**RE: BONNICK ROAD WASTE MANAGEMENT
FACILITY REDEVELOPMENT APPLICATION
(LANDFILL COMPONENT) –
RESPONSE FOLLOWING REVIEW OF
PROPOSED CONDITIONS**

Schedule 1H – Maps / Plans

Schedule 2H – Maps / Figures

Figure 1 – Acoustic Barriers – Transfer Station structure

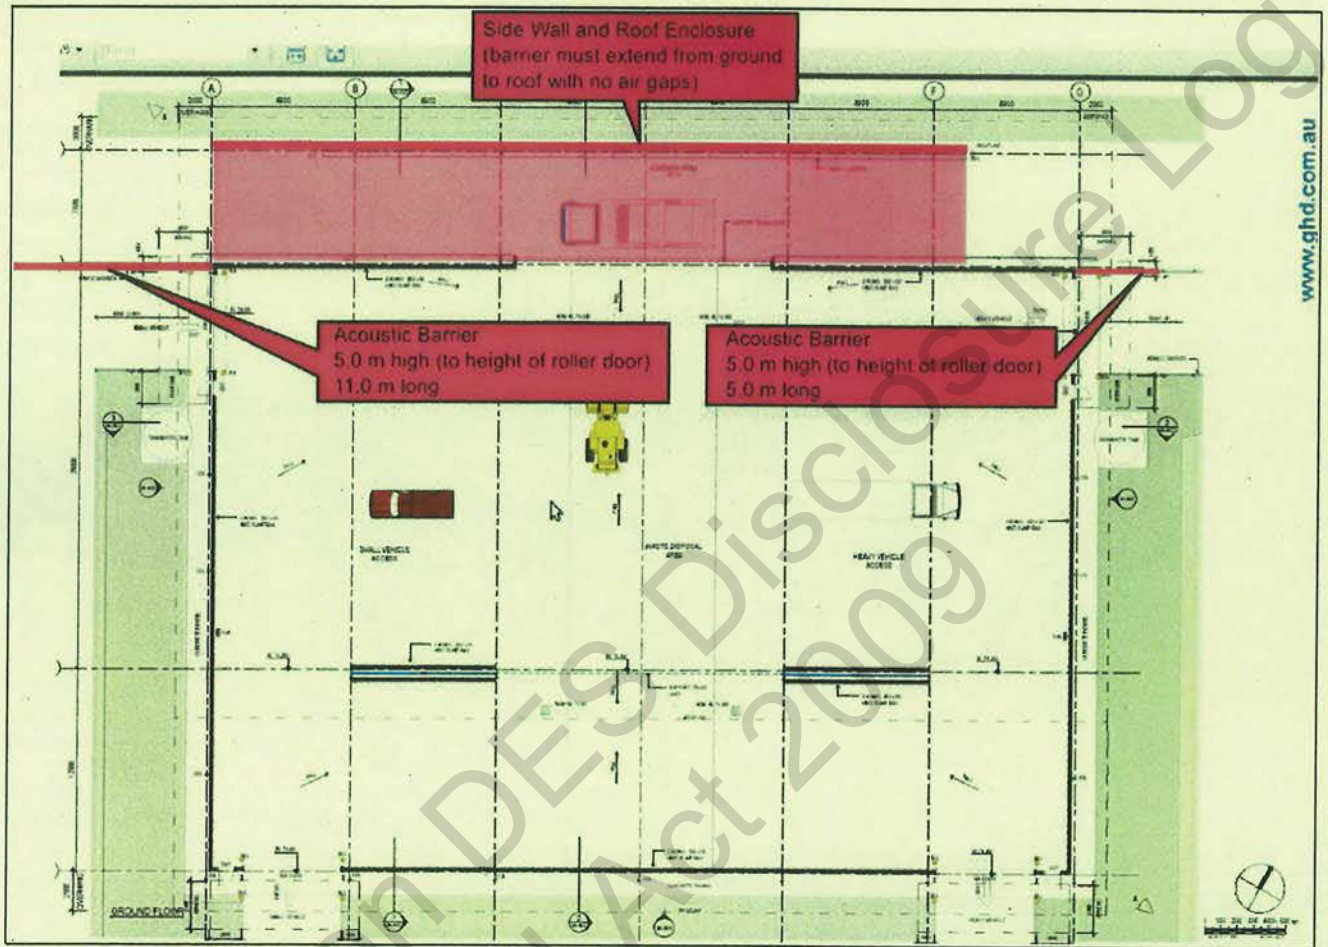
- (2D1-8) Acoustic barriers must;
 - be installed around any waste truck loading area, as per Schedule 2H Figure 1;
 - be installed to a height of at least 5.0m extending from the designed roller doors at the North Western and North Eastern corner of the Transfer Station, as per Schedule 2H Figure 1;

Additional wording to first dot point, as per CTPI 49-Sch4-Nam previous recommendation.
** be installed around any waste truck loading area, as per Schedule 2H Figure 1.*

Schedule H Figure 2 – Acoustic Barrier – Bonnick Road

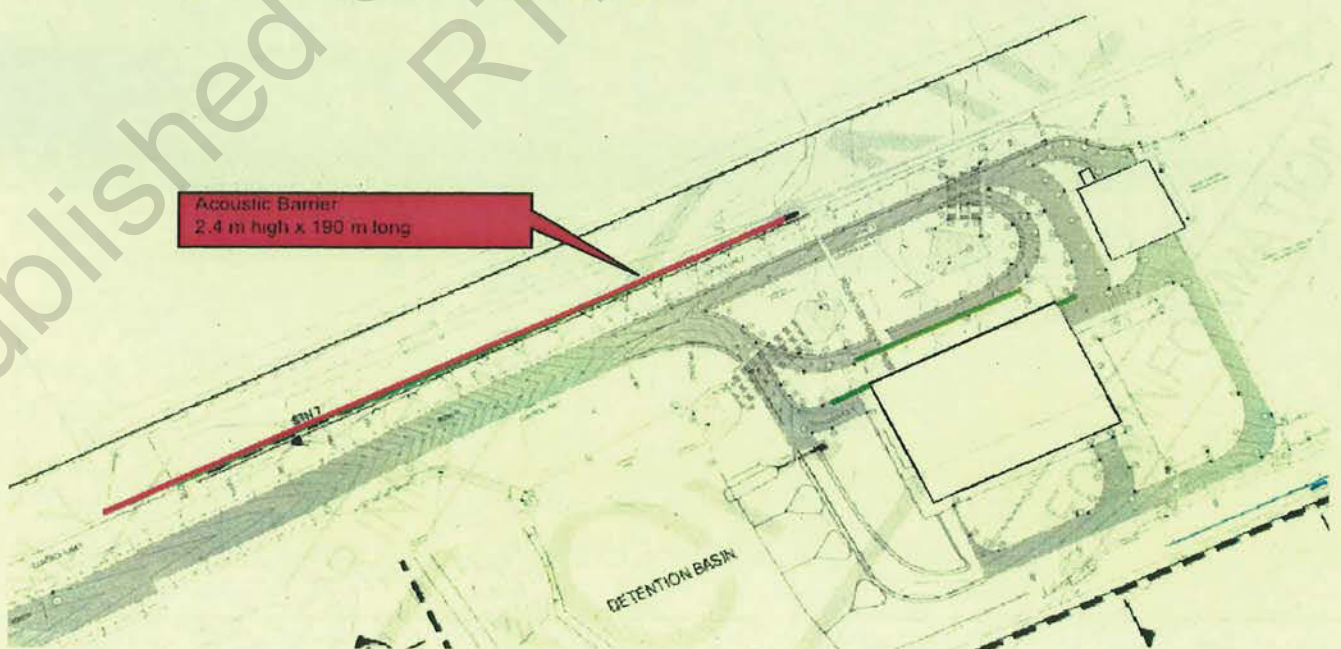
- be installed to a height of 2.4m at the Bonnick Road Boundary, as per Schedule 2H Figure 2;
 - be continuous with no air gaps and be constructed of material with a minimum mass density of at least 12kg/m² or achieve an Rw of at least 20

**HEIGHT OF GCL ABOVE GROUNDWATER
DIAGRAM - GENERAL ARRANGEMENT**

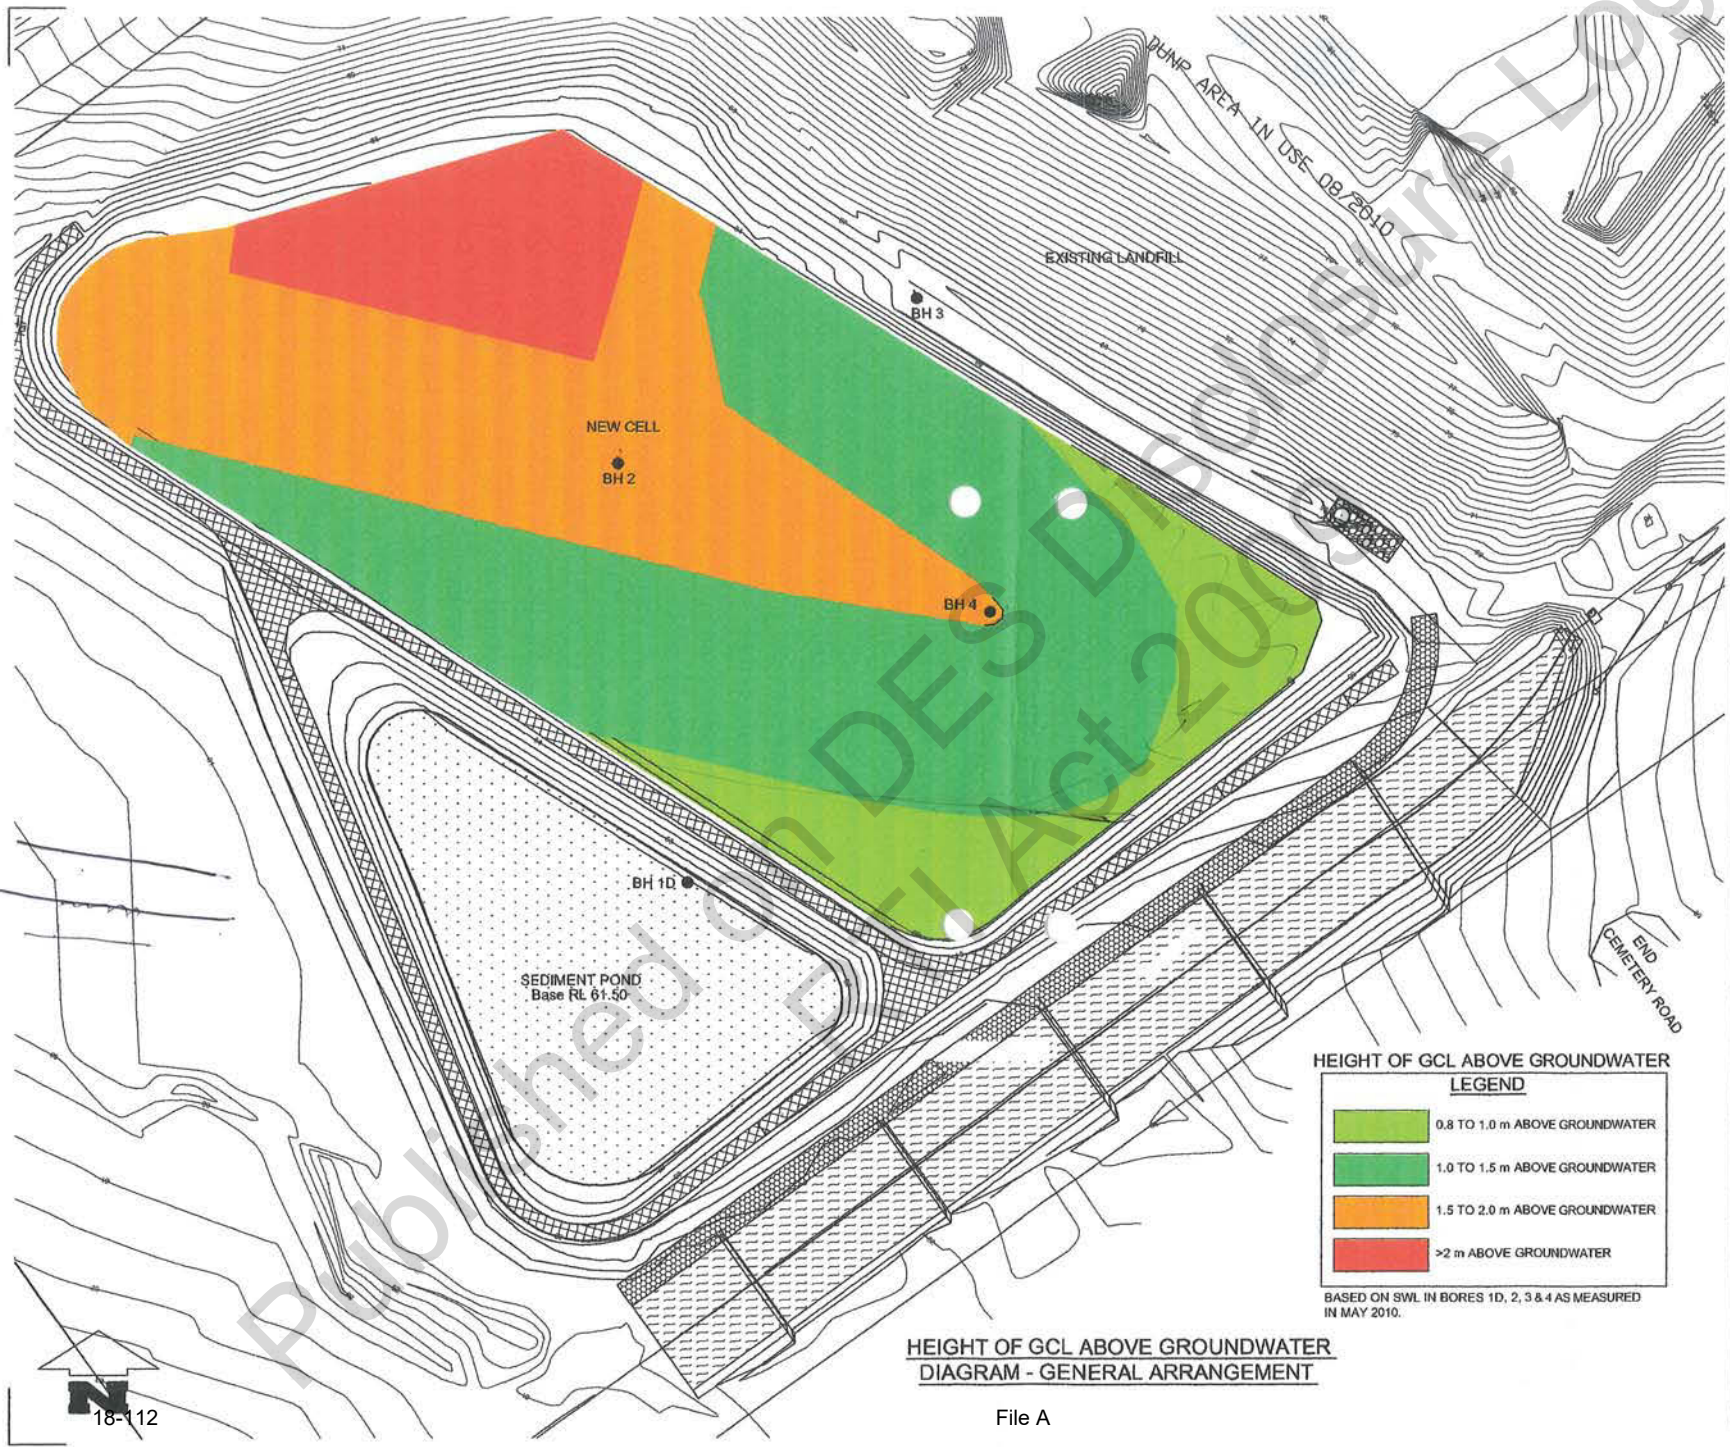
Additional information on flood heights and ground water levels is presented on drawing 09110-02B attached which shows a typical section at a 1:10 distorted scale. It will be noted that the predicted Q100 flood will skirt the proposed landfill extension at RL 61.85. The Q50 flood level is much lower at RL60.08. Thus, on the lowest edge, the GCL will be between 150mm and 2150mm above the Q100 event. In addition the GCL will be placed on a 600mm low permeability clay layer and surrounded by a bund. Relative to seepage times through these clay containment layers, a Q100 event will be quick and therefore expected that such flood events will have no impact on the liner. Never-the less additional precautionary measures have been provided to protect the liner as further described below.

A low permeability fractured rock underlies the majority of the landfill cell tending to a sandy clay towards the southern end. Drawing 09110-02B gives the level of ground water as measured in the bore holes June 2010. It shows that the water table was between 1m and 1.5m below the proposed GCL level. However as a fractured rock substrate it was considered that localised points of higher water table elevations may be possible at any location. It was therefore considered appropriate to install a ground water interception system in the form of "Megaflow" drains as described in section 4.6 of the response. Their function is to relieve any localised areas of high pressure that may occur.

Figure 1 – Acoustic Barriers – Transfer Station structure

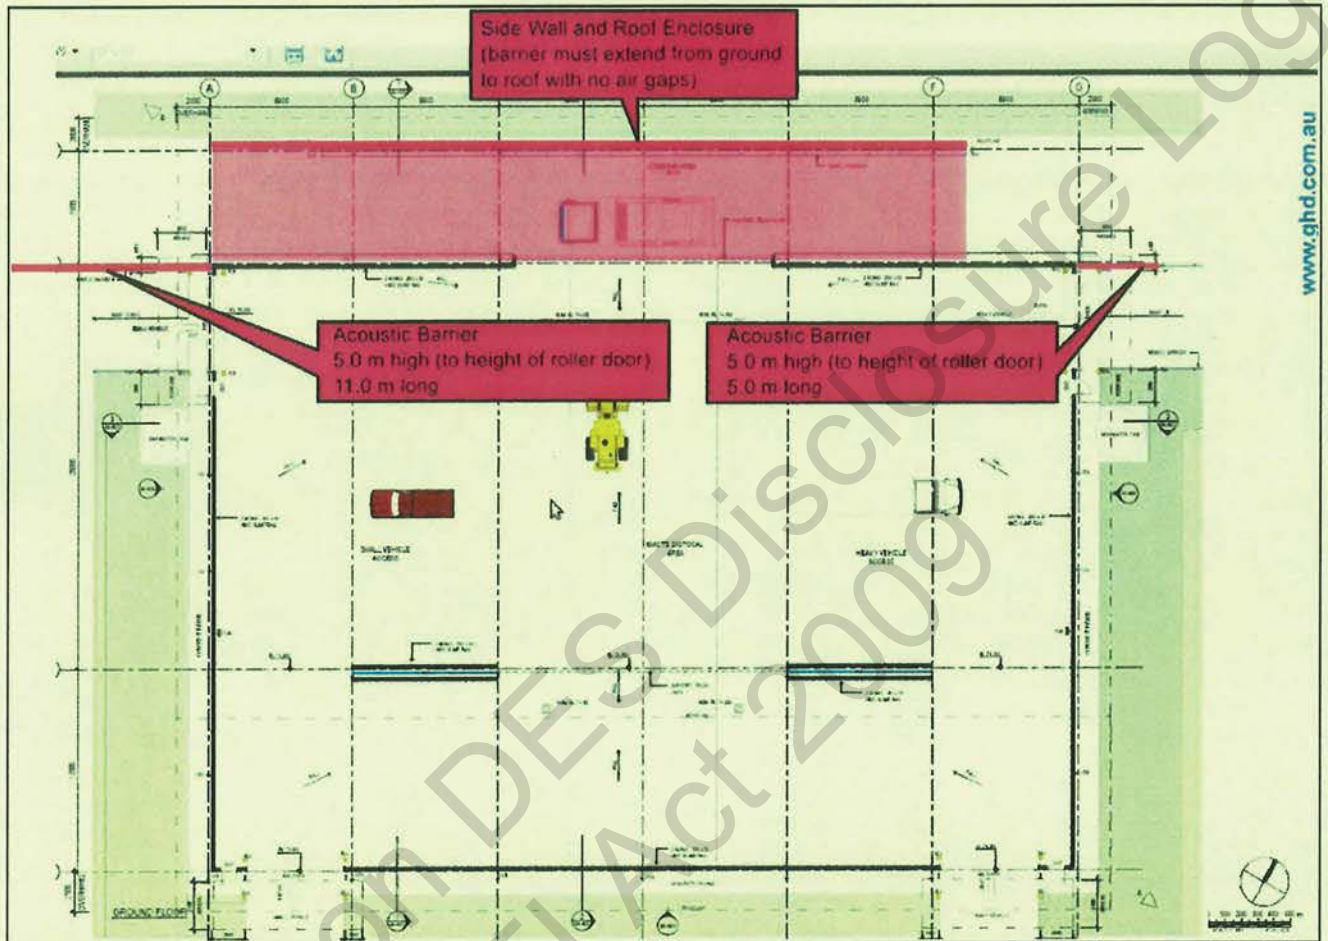
- (2D1-8) Acoustic barriers must;
 - be installed around any waste truck loading area, as per Schedule 2H Figure 1;
 - be installed to a height of at least 5.0m extending from the designed roller doors at the North Western and North Eastern corner of the Transfer Station, as per Schedule 2H Figure 1;

Schedule H Figure 2 – Acoustic Barrier – Bonnick Road

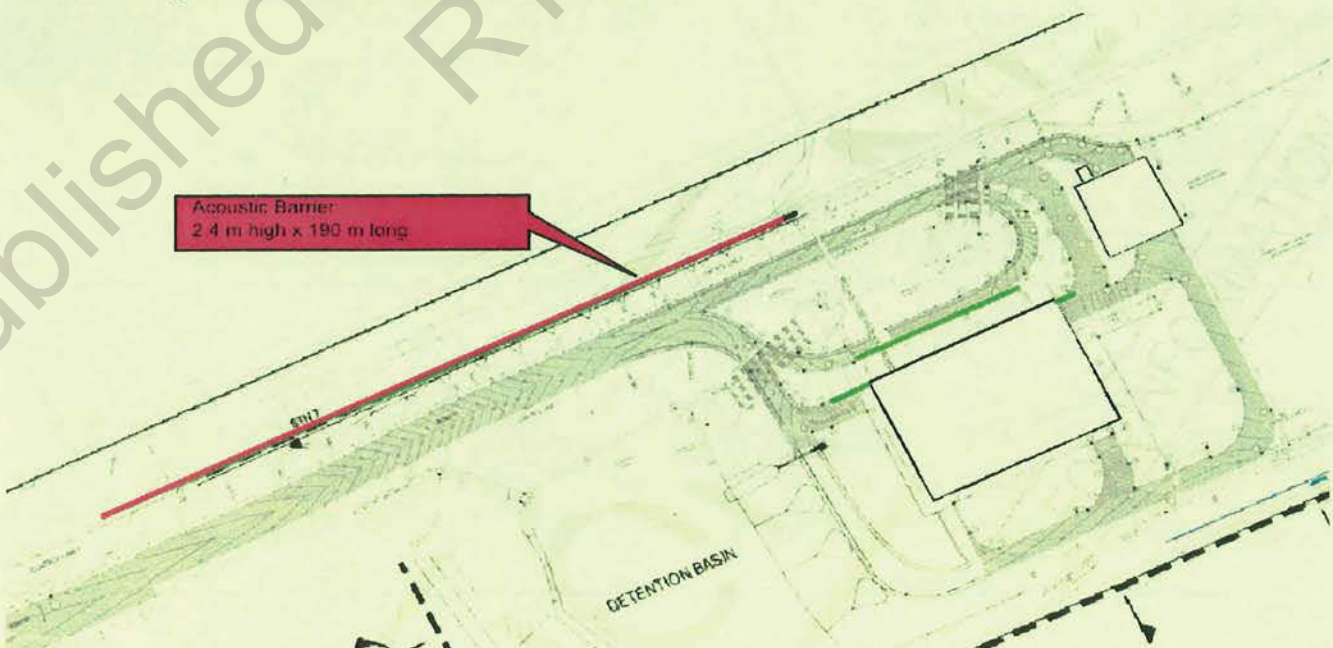
- be installed to a height of 2.4m at the Bonnick Road Boundary, as per Schedule 2H Figure 2;
 - be continuous with no air gaps and be constructed of material with a minimum mass density of at least 12kg/m² or achieve an Rw of at least 20
